Docket Number:	16-AFC-01
Project Title:	Stanton Energy Reliability Center
TN #:	223425
Document Title:	Stanton Energy Reliability Center's Responses to Data Requests A73 through A85
Description:	N/A
Filer:	M. Finn
Organization:	CH2M
Submitter Role:	Applicant Consultant
Submission Date:	5/11/2018 4:00:28 PM
Docketed Date:	5/11/2018

Responses to California Energy Commission Staff
Data Requests A73 through A85

Stanton Energy Reliability Center

Figure DR76-1
Sanitary Sewer Interconnection

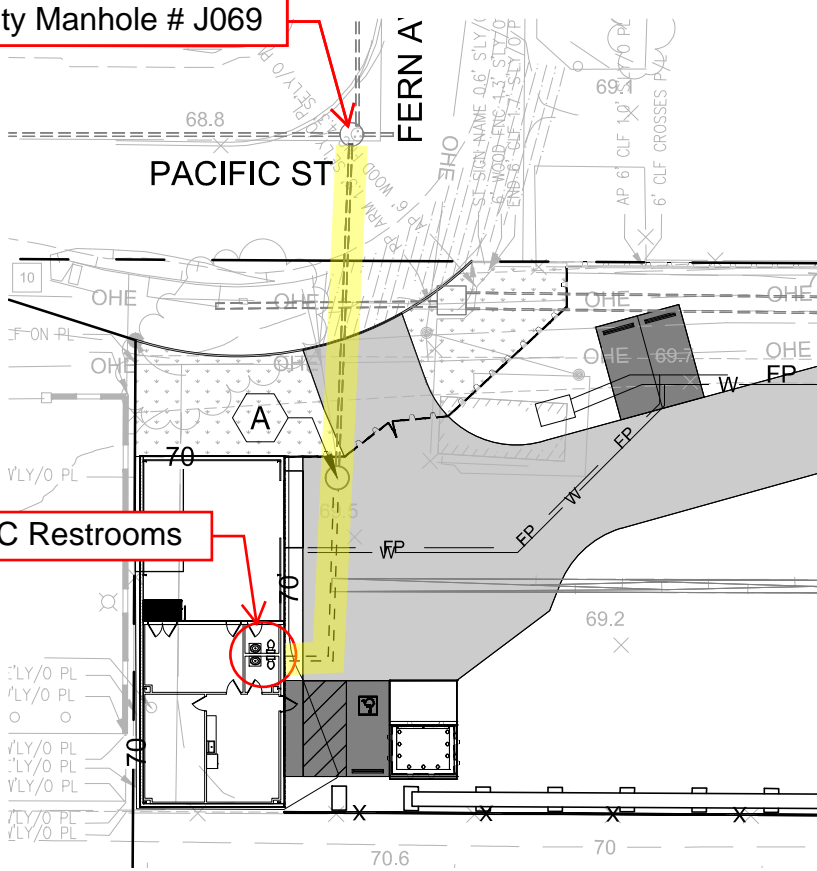
A73. *Please describe how and where the restroom facility would connect to an existing sewer line at the site. Include a description of the length of any new pipeline that would be required and where it would be located.*

A76. *Please include a figure showing the restroom facility and the pipeline alignment that would be connected to it.*

Response: The restroom facility will be in the warehouse building, located on the western end of SERC's Parcel 2. SERC's sewer service provider is the City of Stanton, through a connection to the City's manhole # J069. Manhole # J069 is just outside SERC's Pacific Street entrance, in the Pacific Street and Fern Avenue intersection. Total sewer line length from the restroom location on Parcel 2 to the J069 manhole is approximately 140 feet. The new sewer line will be located completely on SERC's Parcel 2 and within the City of Stanton Pacific Street right-of-way. See Figure DRA76-1 for additional details.

Response: See attached Figure DRA76-1.

INSTALL STD 4' DIA MANHOLE
TOP EL = 69.70'

FLOWLINE IN (S) = 62.51'
(INSTALL 6" DIA PVC PLUG
UNTIL LINE IS CONSTRUCTED
TO THIS POINT. SANITARY
LINE SHALL BE 10' MIN CLEAR
OF WATER LINES)

FLOWLINE OUT (N) = 62.26'
INSTALL 68 LF 8" DIA PVC PIPE
@ 1.00% SL
TIE INTO EXISTING MANHOLE

Figure DRA79-1
Stanton Energy Reliability Center
Foundation Profile
 Stanton Energy Reliability Center AFC
 Stanton, California

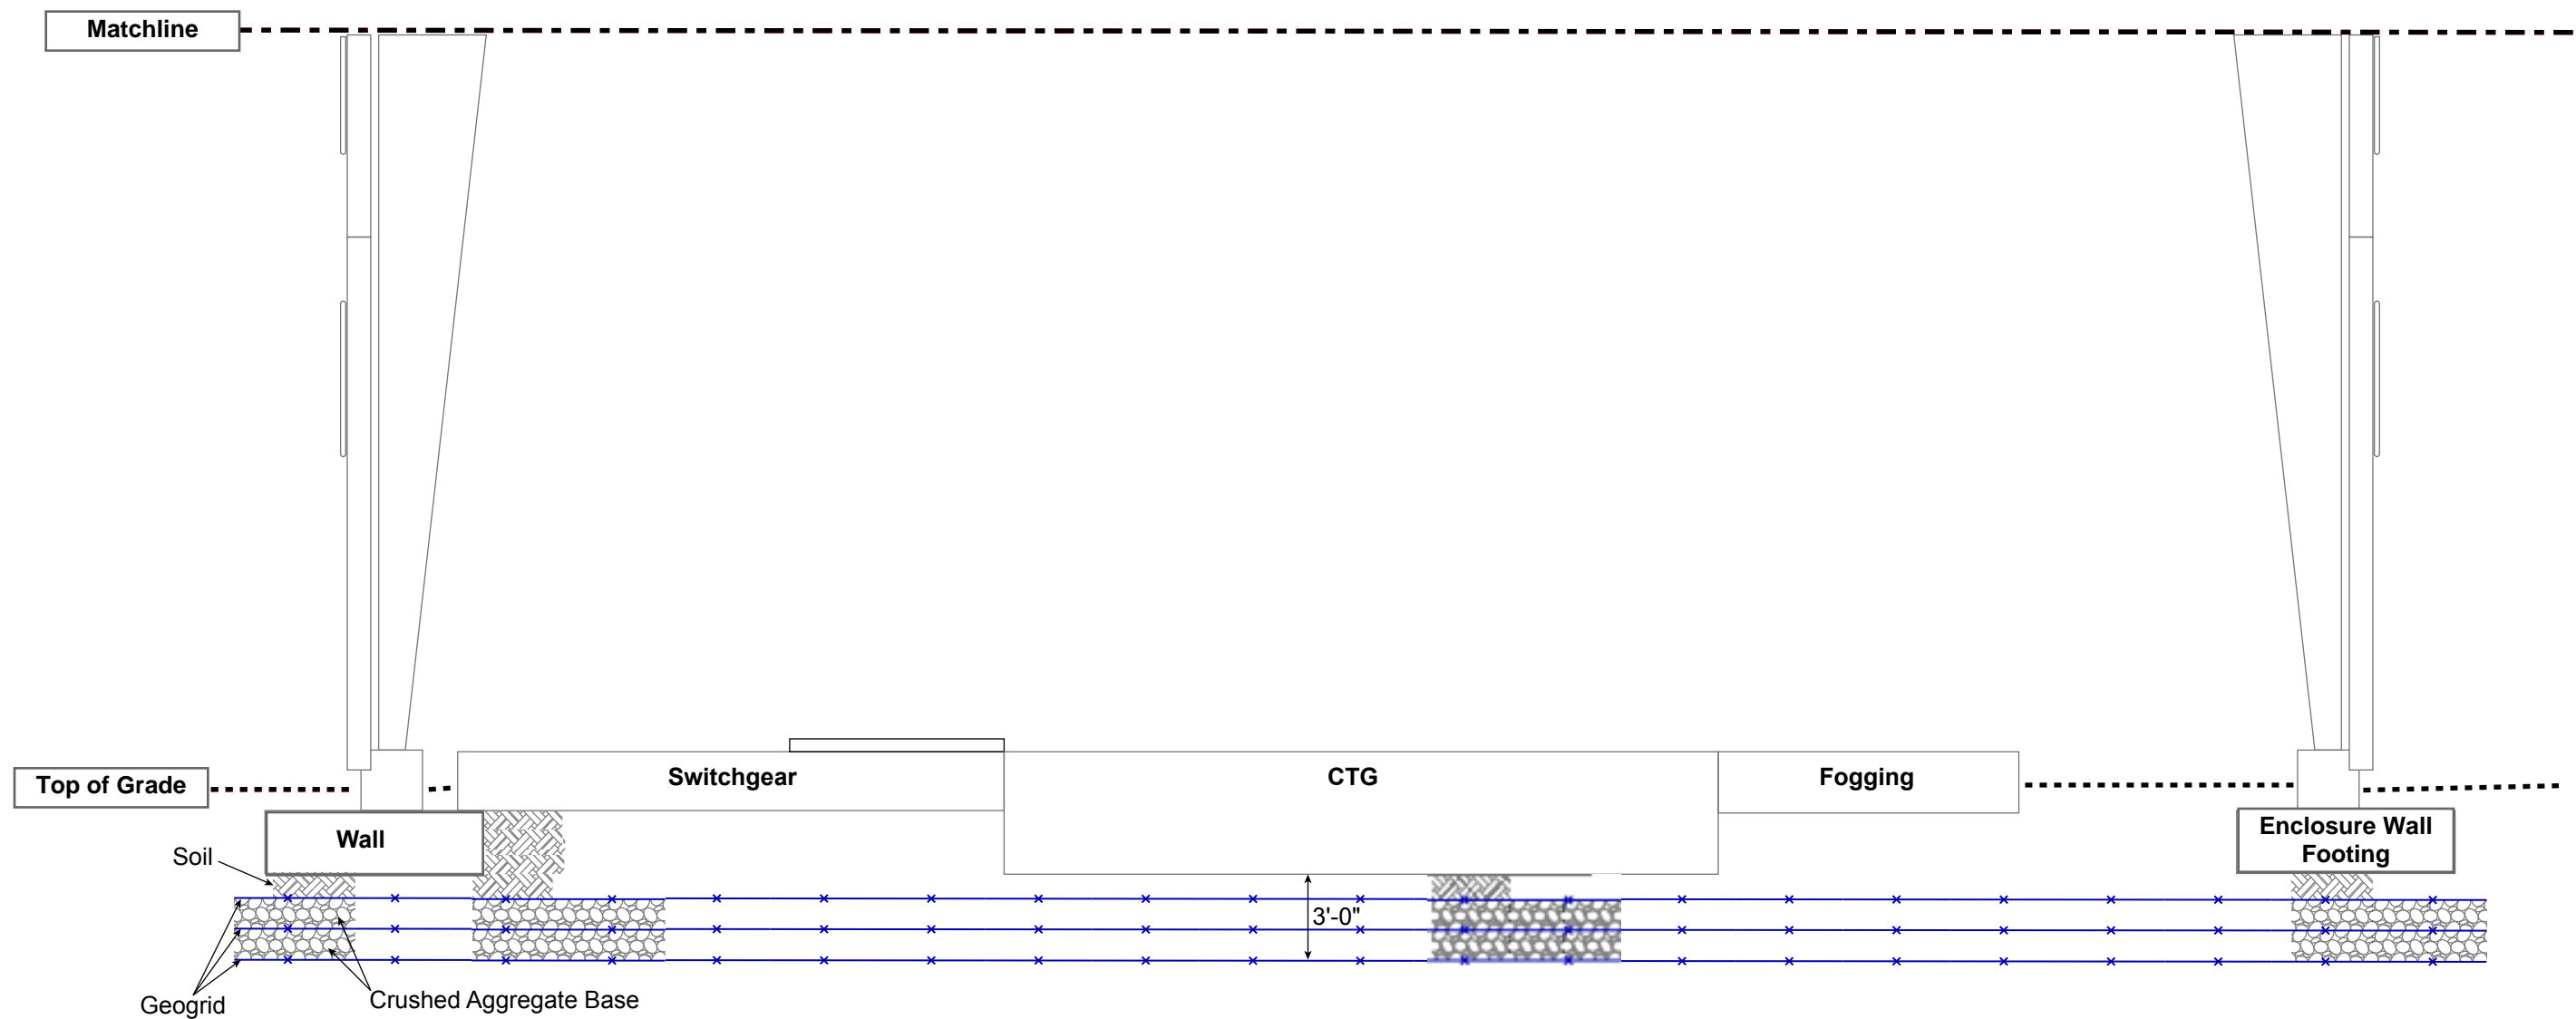
A79. *Please include a figure and cross-section showing the area of excavation, proposed depths, and foundation improvement design.*

Response: Soils in structure foundation areas will be removed to a horizontal plane at a minimum depth of 3 feet below the bottom of the deepest foundation or 5 feet below existing grade, whichever is deeper, generally extending 5 feet laterally beyond the perimeter of foundations. The exposed soil surface will be scarified to a depth of 12 inches, moisture conditioned, and compacted to a minimum of 90 percent relative compaction (per ASTM D 1557) prior to placing any fill. A minimum of two layers of 12-inch-thick geogrid-wrapped crushed aggregate base (CAB), compacted to at least 95 percent relative compaction (per ASTM D 1557) will be placed at the bottom of the over-excavated area. The CAB will conform to the Standard Specification of Public Works Construction (SSPWC) Section 200-2.2 for CAB. The reinforcing geogrids will be Tensar TriAx T160 or equivalent, overlapped a minimum of 3 feet for the bottom layer and 1 foot for the two upper layers.

Response: See attached Figure DRA79-1.
